HISTORIC AND DESIGN REVIEW COMMISSION

HDRC CASE NO: 2020-414
ADDRESS: 1010 BURNET ST
LEGAL DESCRIPTION: NCB 1660 BLK H LOT E 25 FT OF 3 & W 12.5 FT OF 4
ZONING: R-6, H
CITY COUNCIL DIST.: 2
DISTRICT: Dignowity Hill Historic District
APPLICANT: Benjamin Lopez/BURNET ST LLC
OWNER: Benjamin Lopez/BURNET ST LLC
TYPE OF WORK: Rehabilitation, exterior and fenestration modifications, addition
APPLICATION RECEIVED: September 17, 2020
60-DAY REVIEW: Not applicable due to City Council Emergency Orders
CASE MANAGER: Edward Hall

REQUEST:

Ben Lopez
R. ADDITION
ROOF PLAN

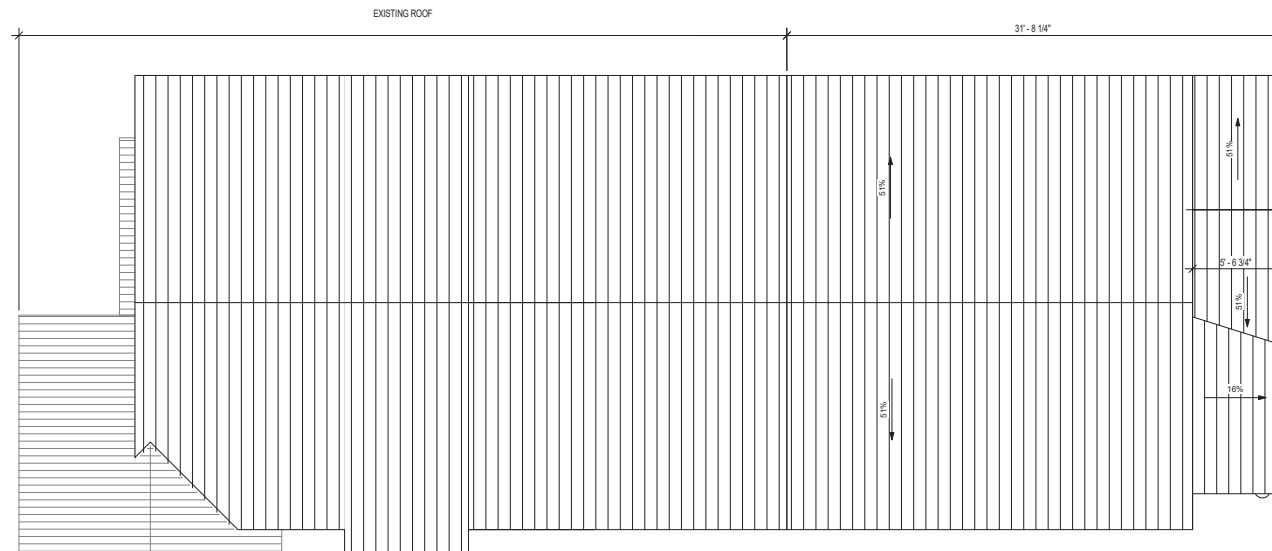
- i. ROOF FORM – The applicant has proposed to install a gabled roof to match that of the historic structure. Staff finds this to be appropriate and consistent with the Guidelines. Per the drawings, it appears that the proposed roof form will feature a slight increase in height of the historic roof form. Staff finds that the two roofs should feature a common height and ridgeline.

- ii. That the proposed addition's roof be consistent with that of the primary historic structures in massing, height and profile, as noted in finding i.

Ben Lopez
R. ADDITION
ELEVATIONS

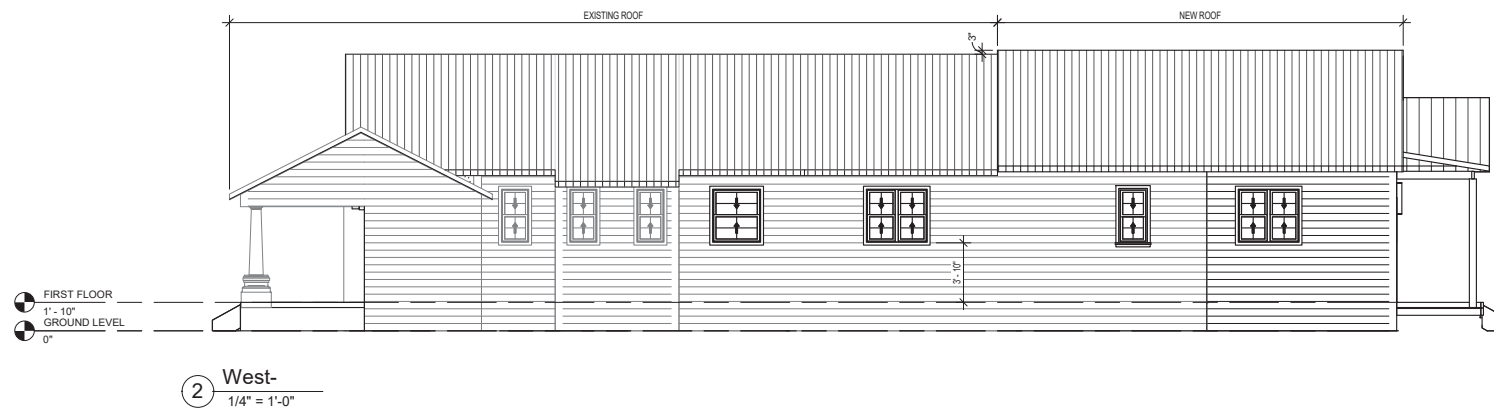
- h. REAR ADDITION – The applicant has proposed to construct a rear addition to feature approximately 350 square feet. The proposed addition will require modifications to an existing rear addition. The Guidelines for Additions 1.A. states that additions should be sited to minimize visual impact from the public right of way, should be designed to be in keeping with the historic context of the block, should utilize a similar roof form and should feature a transition between the old and the new. Generally, staff finds the size of the proposed rear addition to be appropriate and consistent with the Guidelines regarding footprint, scale and massing. The applicant has proposed an inset on the east façade to differentiate the historic structure from the addition. Staff finds that this should also be incorporated into the west façade, or that a vertical trim piece should be installed.

- k. MATERIALS – The applicant has proposed materials that include a standing seam metal roof and wood siding to match that of the historic structure's. Staff finds the proposed siding to be appropriate; however, staff finds that the proposed standing seam metal roof should feature panels that are 18 to 21 inches in width, seams that are 1 to 2 inches in height, a crimped ridge seam and a standard galvalume finish. A ridge cap is not to be used.

3. Staff recommends approval of item #3, the construction of a rear addition with the following stipulations:
 - i. That an inset or vertical trim piece be incorporated into both elevations, as noted in finding h.

- iii. That the proposed standing seam metal roof feature panels that are 18 to 21 inches in width, seams that are 1 to 2 inches in height, a crimped ridge seam and a standard galvalume finish. A ridge cap is not to be used.
